**City of Santa Cruz**

**DOWNTOWN  
~~RECOVERY~~ PLAN**

**As Amended through ~~February~~  
2016**

[On 2016, the City Council adopted revisions to the plan with specific emphasis on Chapter 4, Development Standards and Design Guidelines as Ordinance XXXXX, extending Additional Height Zone A to Laurel Street and modifying Additional Height Zone B for Front Street riverfront properties.](#)

**HEIGHT**

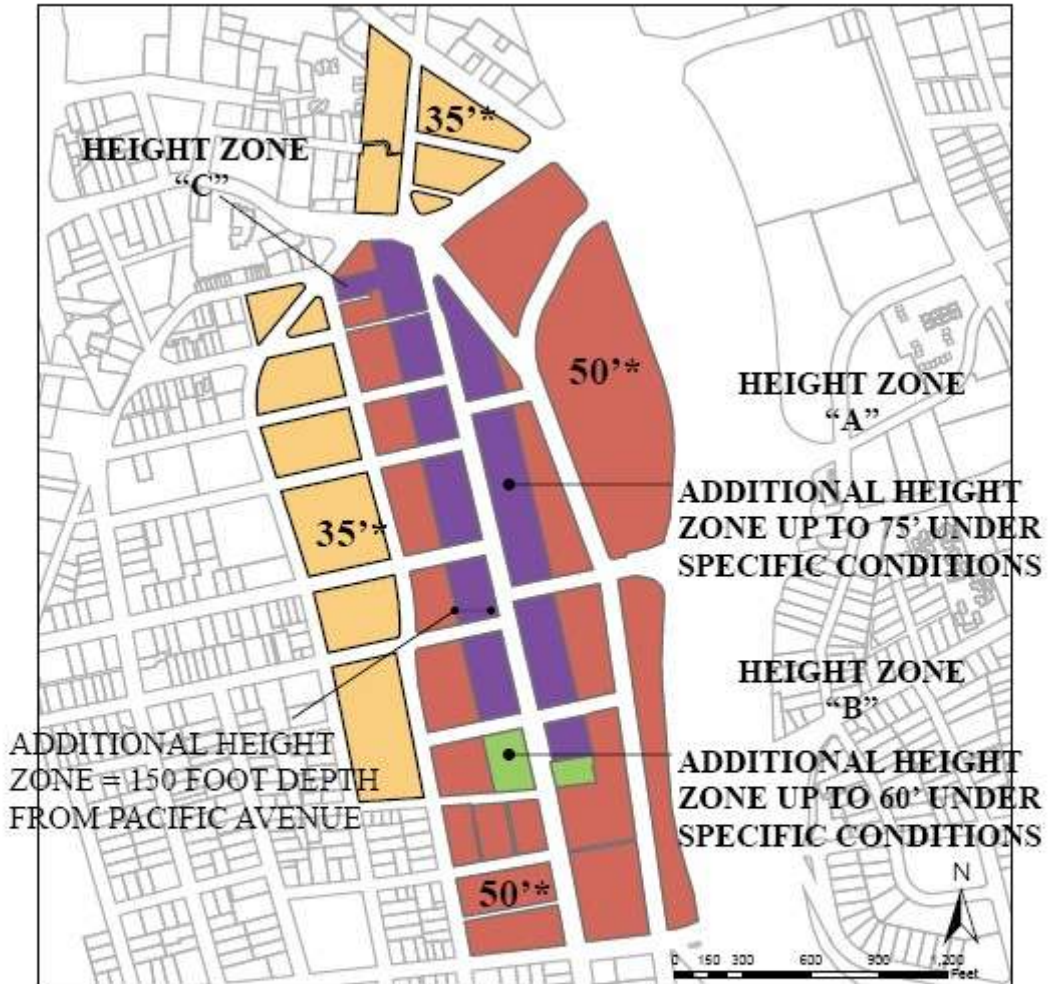
**NOTE: The High Density overlay map will be eliminated as the General Plan 2030 land use designations have FAR ranges that supersede the HDO district.**

Pacific Avenue

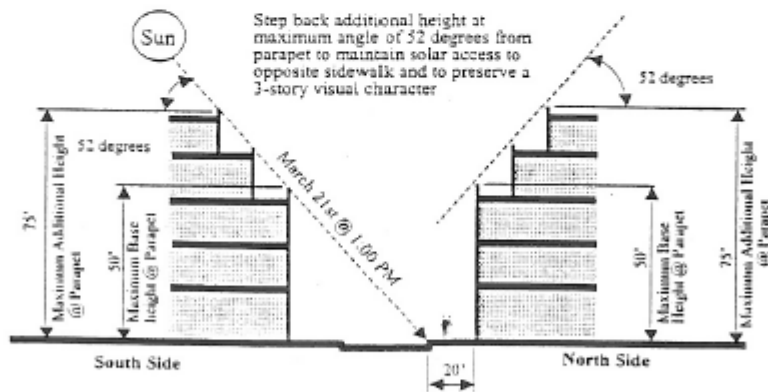
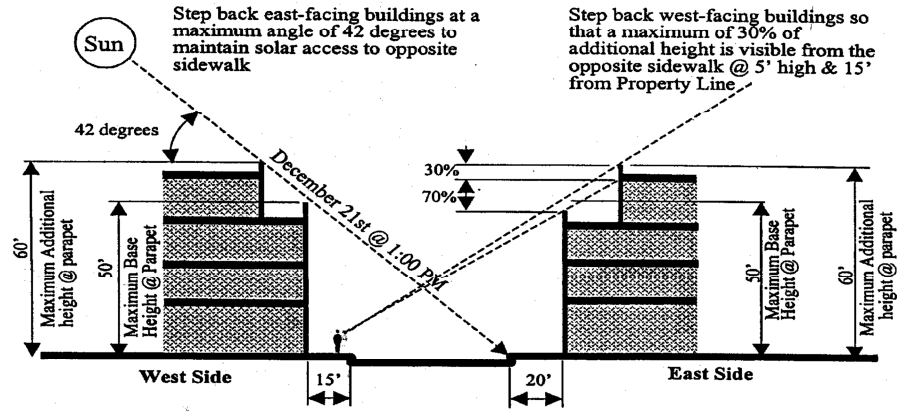
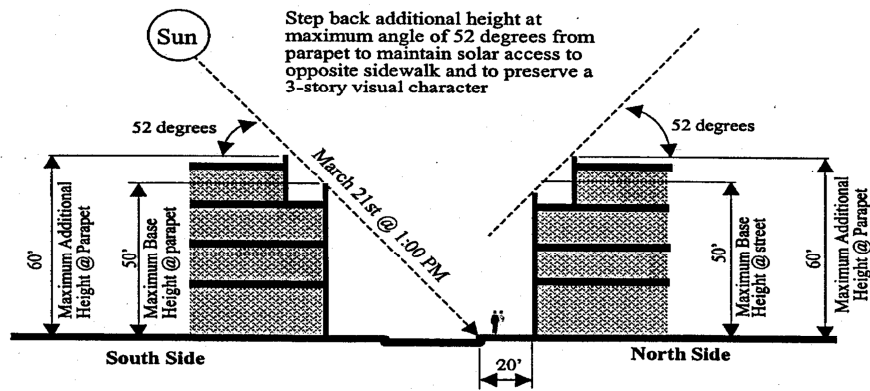
THE EXISTING CROSS SECTIONS APPLY ONLY TO ADDITIONAL HEIGHT ZONES, SO THESE GRAPHICS WILL BE DELETED AND REPLACED WITH RELEVANT NEW GRAPHICS IN THE ADDITIONAL HEIGHT ZONE SECTION.
